UNITED STATES PATENT AND TRADEMARK OFFICE

APPLICATION NO.	FILING DATE	FIRST NAMED INVENTOR	ATTORNEY DOCKET NO.	CONFIRMATION NO.
10/009,696	11/06/2001	John Eric Arnold	DN1999111USA	1392

Office Action Summary	Application No.		Applicant(s)	
	10/009,696		ARNOLD ET AL.	
	Examiner		Art Unit	
	Lan Nguyen		3683

DETAILED ACTION

FIG. 4

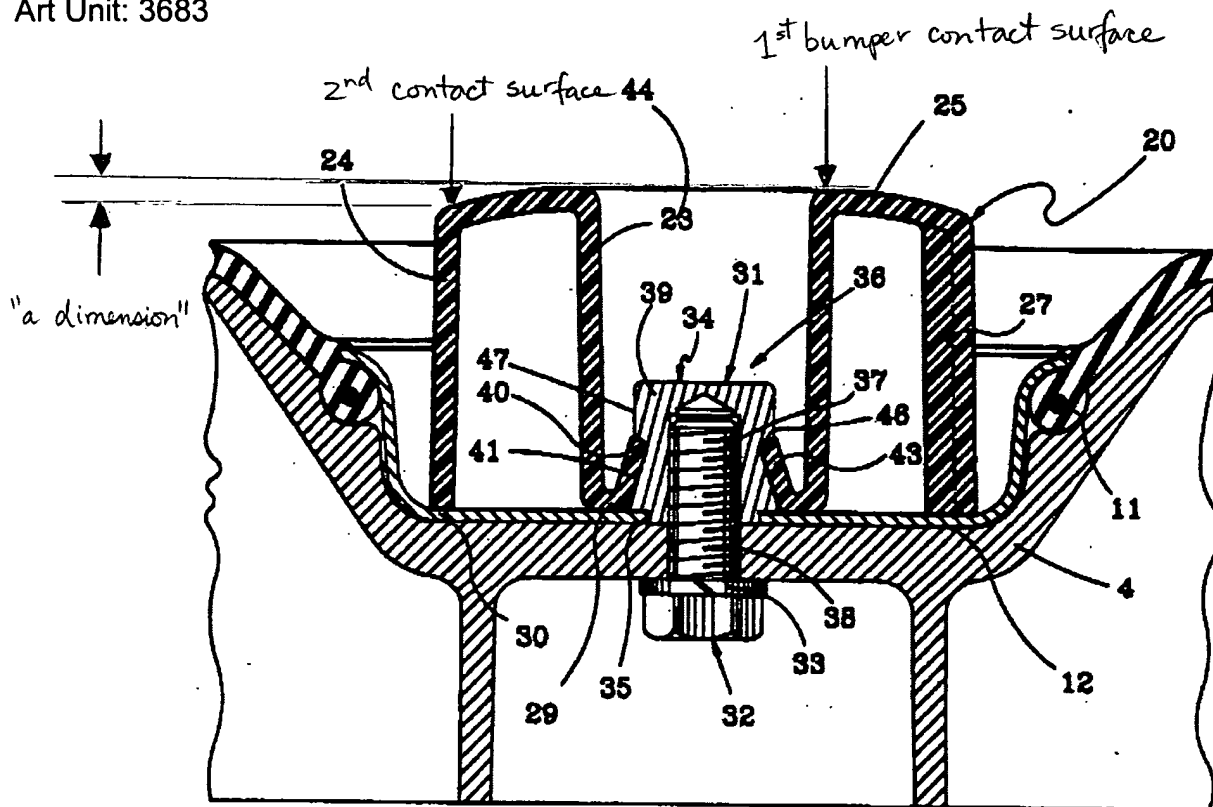
Re: claims 2, 3 and 4, Ecktmann shows support ribs 43, 26, 27, 29, 30 wherein said ribs are substantially radially extending; and are a series of concentrically disposed.

Re: claim 5, Ecktmann shows the first contact surface to be closer to the center corresponds to rib 29, the second contact surface to be further out corresponds to rib 30 and are separated by a dimension, please see the marked up figure above.

Re: claim 12, Ecktmann shows two concentrically disposed ribs 30, 29.

Re: claim 18, Ecktmann shows the axially outer surface to be closer to the center corresponds to rib 29, the second axially outer surface to be further out corresponds to rib 30 and are separated by a dimension, see marked up figure above.

Re: claim 19, Ecktmann shows the axially outer contact surface to be closer to the center corresponds to rib 29.
